UNITED STATES PATENT AND TRADEMARK OFFICE

APPLICATION NO.	FILING DATE	FIRST NAMED INVENTOR	ATTORNEY DOCKET NO.	CONFIRMATION NO.
10/756,214	01/12/2004	Rajiv Doshi	2502230-991101	1165
26379	7590	01/12/2005		
DLA PIPER RUDNICK GRAY CARY USA, LLP 2000 UNIVERSITY AVENUE E. PALO ALTO, CA 94303-2248				
EXAMINER MCKANE, ELIZABETH L				
ART UNIT		PAPER NUMBER		
1744

Office Action Summary

FIG. 4

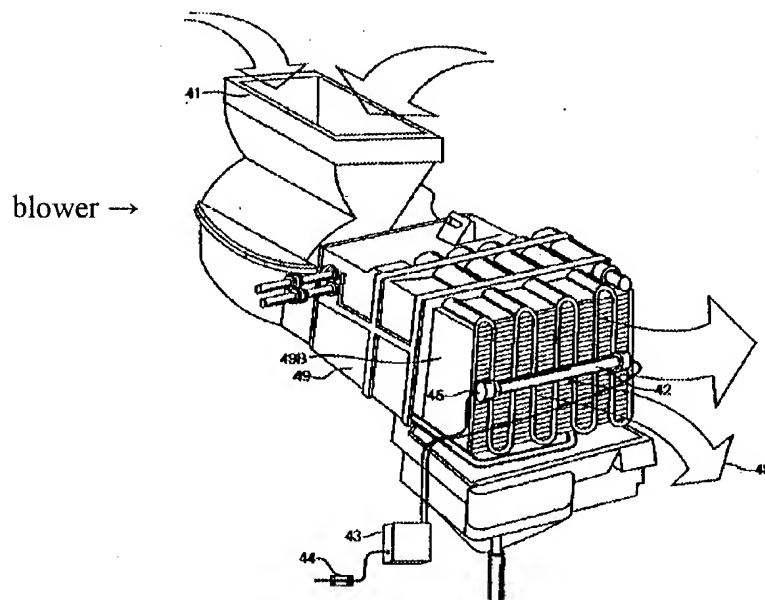
Hollander teaches an HVAC system and method for a motor vehicle comprising a UV bulb **42** for treating microorganisms with the HVAC system. The UV bulb emits light at 254 nm (UVC). See Figure 3. The UV bulb **42** is located in the post-blower (unlabeled) portion of the HVAC system, adjacent and downstream of the evaporator **49B** at the air exit **48**.

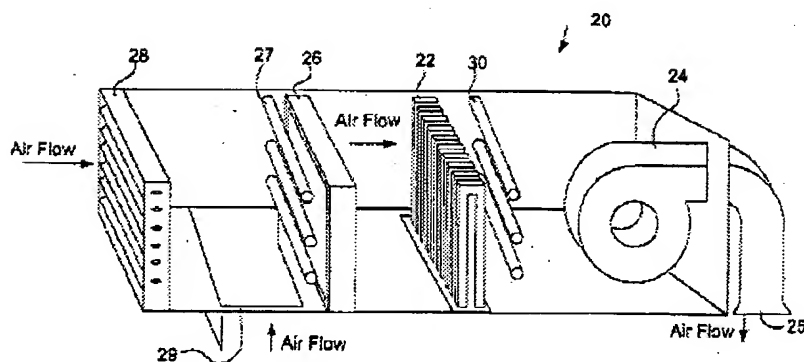
Although Hollander does not expressly teach that the HVAC system has a plurality of conduits for communicating air within the vehicle, it is well-known in the art that the HVAC systems of motor vehicles have a plurality of conduits, evidenced by the multiple air vents within a vehicle interior. Moreover, Hollander discloses that the interior of the air duct “is reflective of the ultraviolet energy (254 nm)” in order to direct the UV radiation throughout the duct and to intensify sterilization effects. See col.7, lines 34-39. For this reason, it would have been obvious to fabricate the interior of all air ducts of a reflective material.
